METROPOLITAN GOVERNMENT OF NASHVILLE AND DAVIDSON COUNTY

STAFF RECOMMENDATION
318 51st Avenue North
November 19, 2014

Application: New construction-infill and outbuilding
District: Park and Elkins Neighborhood Conservation Zoning Overlay
Council District: 24
Map and Parcel Number: 09115021000
Applicant: John Zelenak, Aspen Construction
Project Lead: Sean Alexander, sean.alexander@nashville.gov

Description of Project: The applicant proposes to construct a one and one half-story house on a vacant lot, with a detached outbuilding at the rear.

SITE SETBACK PLAN
OF
318 51ST AVE. N., NASHVILLE, TENNESSEE

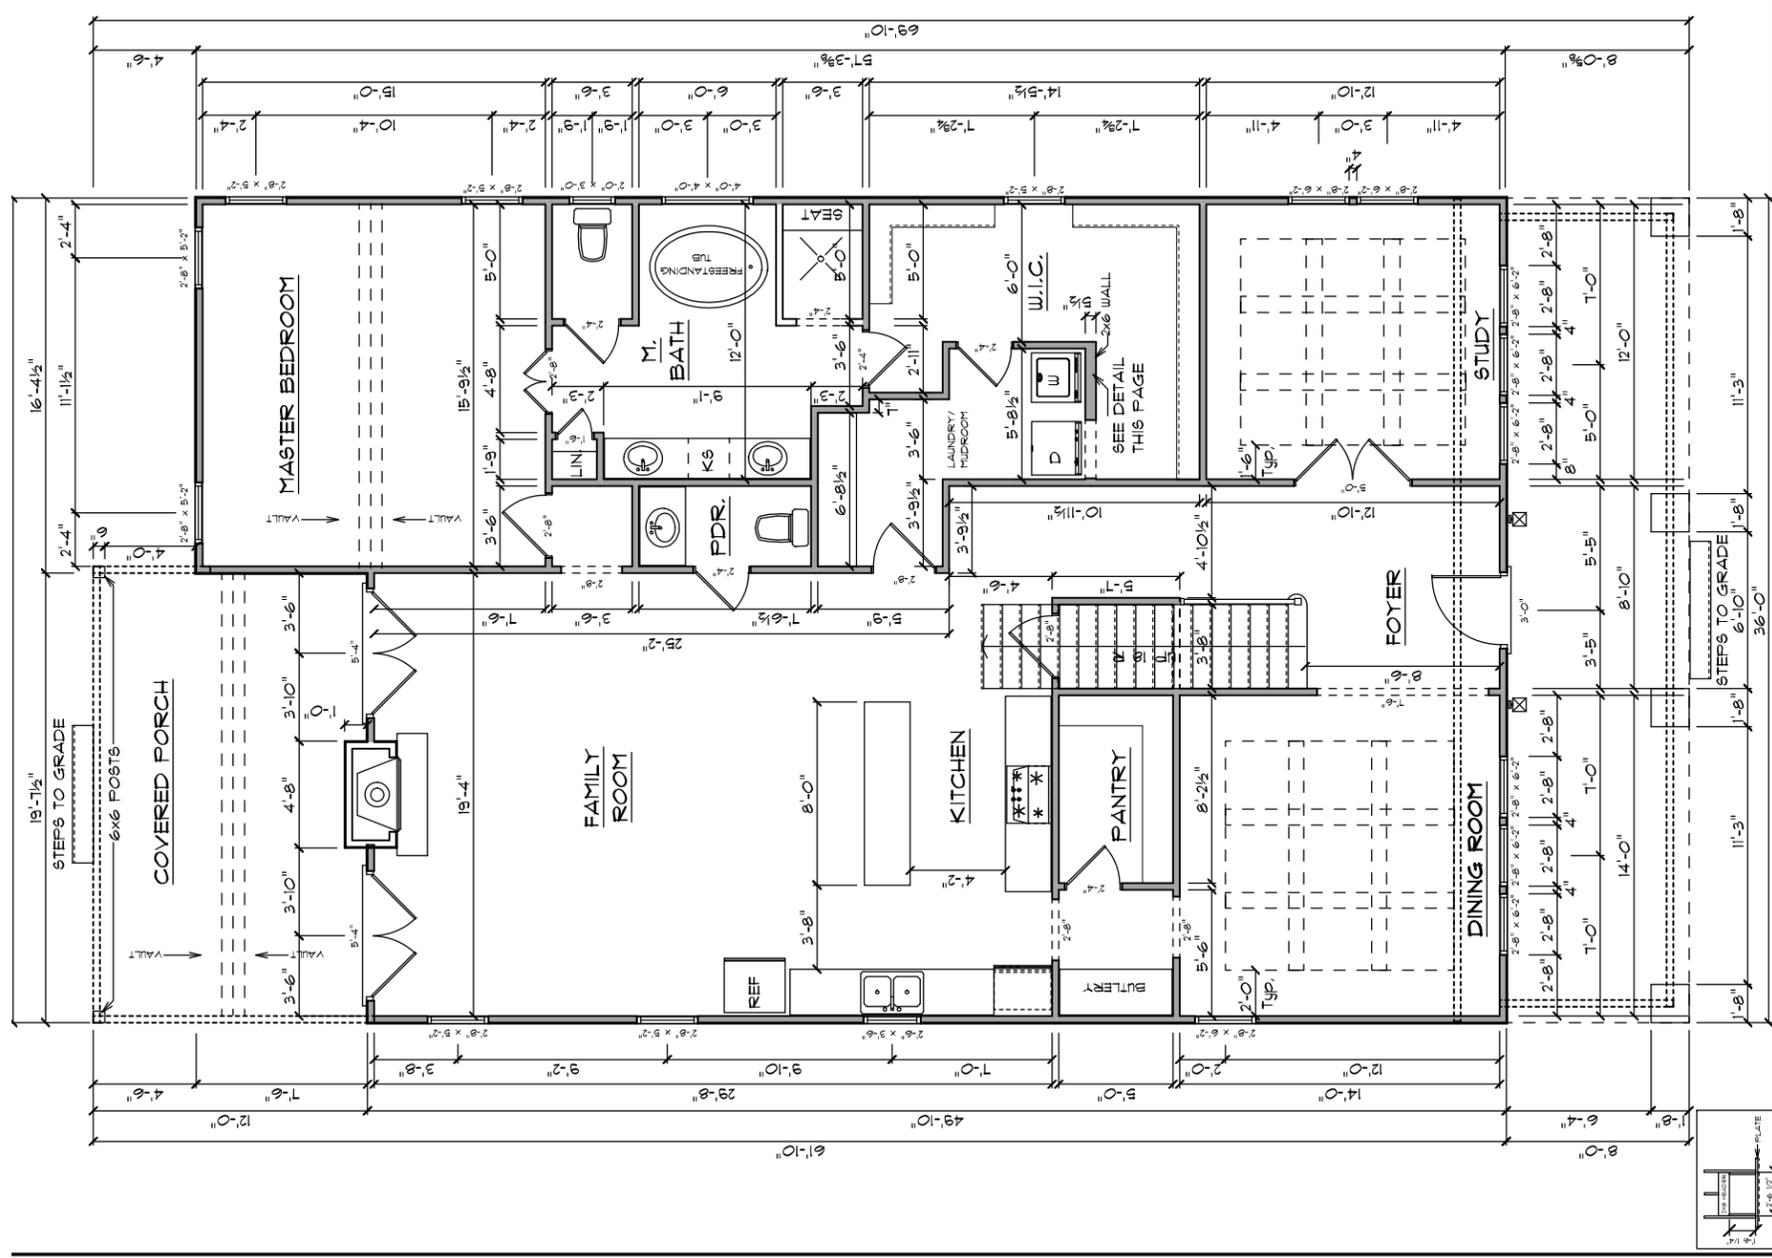
The house will be thirty-six feet (36') wide and fifty feet (50') deep, with an eight foot (8') deep front porch and a twelve foot (12') deep rear porch bringing the total depth to seventy feet (70'). The approximate widths of surrounding homes on similar fifty-foot (50') wide lots range between twenty-seven and thirty-three feet (27' to 33'). There is one house nearby that is thirty-six feet (36') wide, but the house is on a fifty-six foot (56') wide lot. Staff finds that the width of the proposed house would be greater than the surrounding houses on similarly sized lots, and would therefore not be compatible. With a condition that the width of the house be reduced three feet (3'), Staff finds that the project would meet section II.B.1.a. and b.

Setback & Rhythm of Spacing: The building will sit thirty-four feet (34') back from the front edge of the property, in line with adjacent historic houses. The house will be centered on the lot with a seven foot (7') setback on both sides. Staff finds that these

setbacks are consistent with those of surrounding historic houses. The project meets section II.B.1.c.

- The width of the house be reduced three feet (3'); and
- Staff approves the final selection of windows and doors, and the roof color; and
- Staff approves appurtenances; and
- The HVAC is located on the rear or side of the building behind the midpoint.

ROOF PLAN
SCALE: 1/4" = 1'-0"

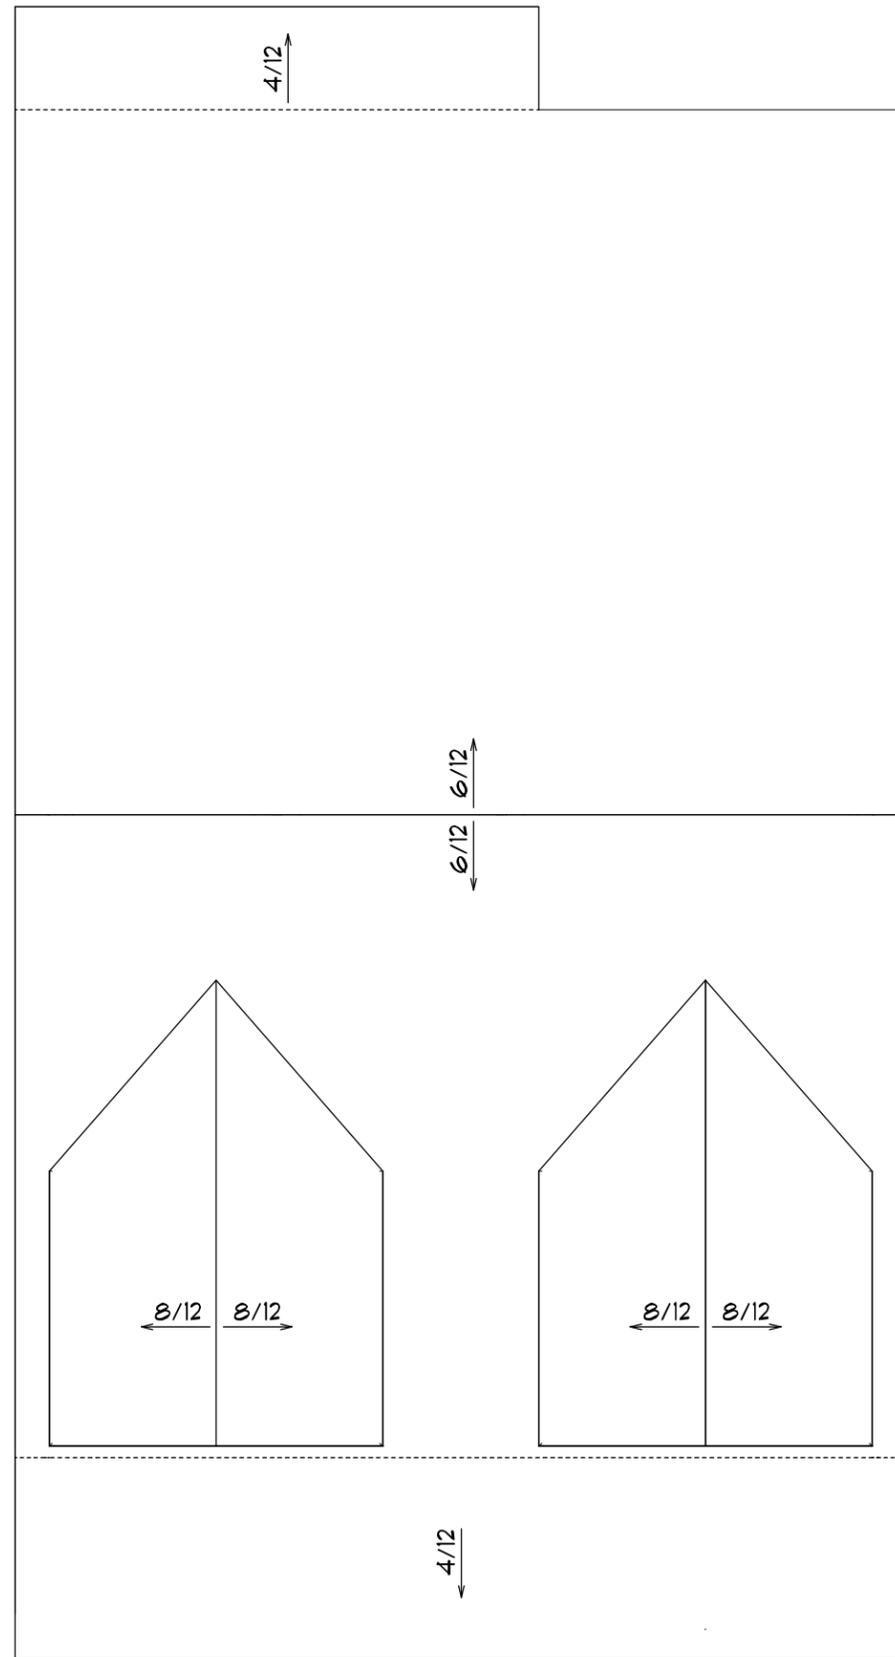
Roof form: The roof will be a side-oriented gable with a pitch of 6:12. The front slope of the roof will have a pair of gabled dormers with an 8:12 pitch. The shed-roof porch has a pitch of 4:12. These front dormers will sit two feet (2') back from the front wall of the first-story and two feet (2') in from the side walls, with eight feet (8') of separation between them. These roofs are compatible with those of historic houses in the area. The project meets section II.B.1.e.

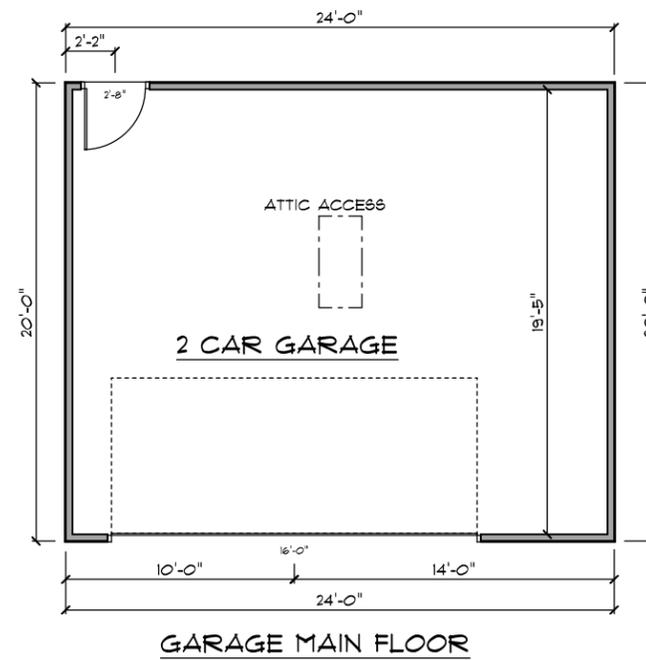
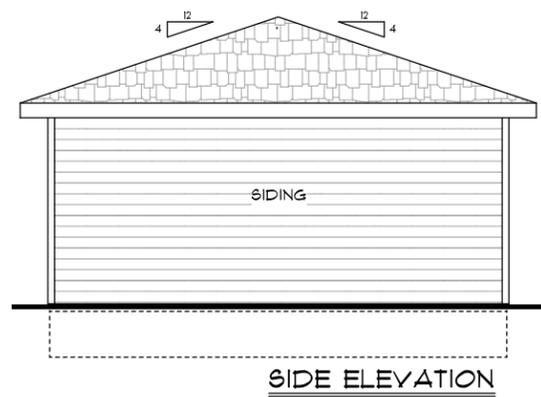
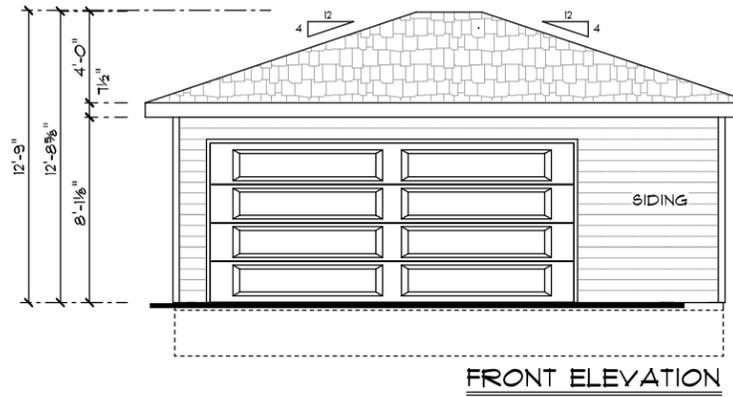
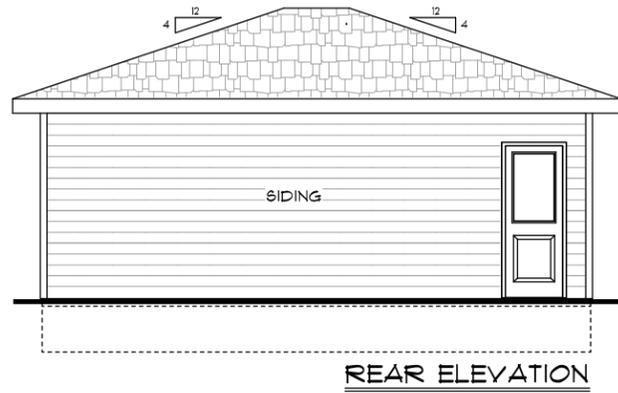
Height & Scale: The new house will be one and one-half stories tall. This is compatible with the surrounding historic context, consisting of one and one-half story Craftsman and Transitional Victorian houses. The peak of the roof will be twenty-eight feet (28') above the finished floor level. With a two-foot (2') tall exposed foundation, the overall height of the building will be thirty feet (30'). The leading eave of the house will be twelve feet (12') above the finished floor level. By comparison, surrounding houses are between nineteen and thirty feet (19' to 30') tall. Staff finds the height of the proposed building to be compatible with surrounding houses.

Materials: The house will have a split-faced block foundation, smooth-faced cement-fiber siding with a five inch (5") exposure, composite shingle siding in the dormers, and a composite shingle roof. The roof color is not known. The trim will be cement-fiberboard and the porch columns will be wood with cast-stone pedestals on the porch columns and concrete porch floor and steps. The windows will be wood with fully-simulated divided light sashes, and the front door will be wood. Staff recommends as a condition of approval that the, window and door selections, and the color of the roof, are reviewed and approved by Staff. The project meets section II.B.1.d.

Proportion and Rhythm of Openings: The windows on the proposed infill are generally twice as tall as they are wide, thereby meeting the historic proportions of openings. There are no large expanses of wall space without a window or door opening. Staff finds the project's proportion and rhythm of openings to meet Section II.B.1.g.
